**LEESBURG BOARD OF ARCHITECTURAL REVIEW
STAFF REPORT**

SPECIAL PUBLIC HEARING AND WORK SESSION FOR COURTHOUSE SQUARE PROJECT: 8 AUGUST 2012

BAR Case No. TLHP-2012-0040 Courthouse Square: Commercial Mixed-use Building on Loudoun Times Mirror property. Report #1 was June 4, 2012, Report #2 was June 27, 2012, Report #3 was July 11, 2012 and Report #4 was July 25, 2012.

This is Report #5 – first overall review of all submissions

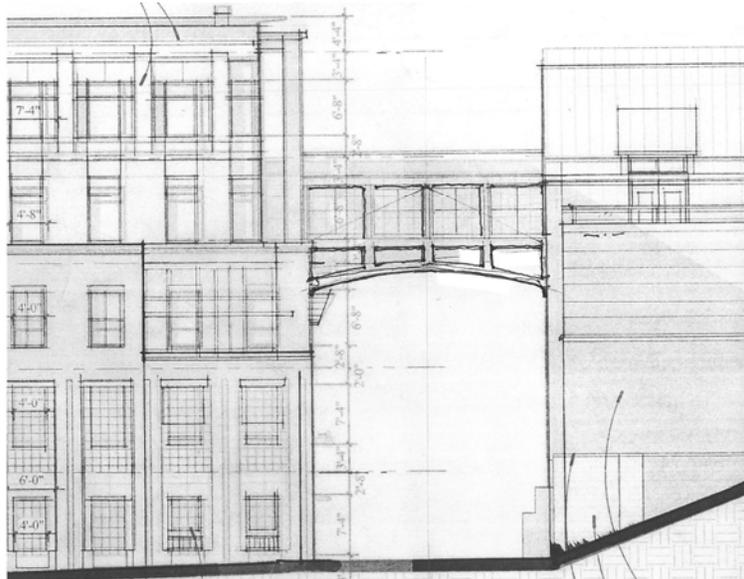
The glass and steel canopy has had cables added for visual support which also ties in with the cable railings that will be used around the entire project in various locations, such as the rooftop addition to the LTM and above the Church Street elevation near Loudoun Street, which is appropriate.

- The curtain wall used to wrap the corner from Loudoun to King and near the main entry has been found to not be considered an extensive use of a non-traditional material since it is limited to an area located behind the main facades of Loudoun Street and is limited in area. However, their glazing area proportions should follow the fenestration pattern of reducing the individual lites or glazed areas as it rises up higher on the building. Dividing with mullions seams or muntins should be used to break down the scale to a greater degree than is shown.
